Subject: April FY 2021 Administrative Modification Bundle #1 AB21-12-APR1 Approval Request

# 2021-24 Metropolitan Transportation Improvement Program (MTIP) Metro April 2021Administrative Modification Bundle #1

## Modification Number: **AB21-12-APR1** Resolution: N/A

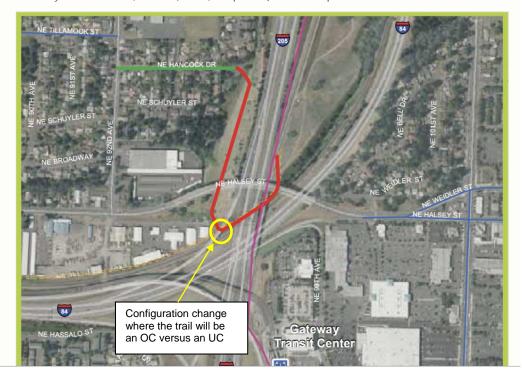
- CHANGE PROJECT NAME: Strike Undercrossing and replace it with Overcrossing The revised project name is now: I-205 Overcrossing (Sullivans Gulch)
- ADJUST MTIP SHORT DESCRIPTION to replace undercrossing with overcrossing. Revised short description is now: Provide safe access across I-205 for bicyclists and pedestrians by improving local street corridors on the west side of I-205 and constructing an east-west bicycle and pedestrian overcrossing
- ADD MTIP DETAILED DESCRIPTION as follows: At I-205 from NE Hancock Dr south to WB I-84 IC, construct new bike/pedestrian OC representing the first section of the Sullivan's Gulch path. Build a new path connecting the I-205 path at Gateway Green on the east side of 205 to NE Hancock Drive on the west side of the freeway plus go over the I-84 westbound on-ramp and use a mix of railroad and vacant ODOT highway right-of-way.

The admin mod updates the project's short description to indicate the crossing at WB I-205 will now be an overcrossing. The project alignment does not change, nor does the total project cost. A copy of the project alignment is included for reference.

The Administrative Modification updates the project name and description to reflect that the Sullivan Gulch trail crossing at the WB I-205 IC will now be an overcrossing. No change in overall alignment and project scope, or cost as a result of the description correction.
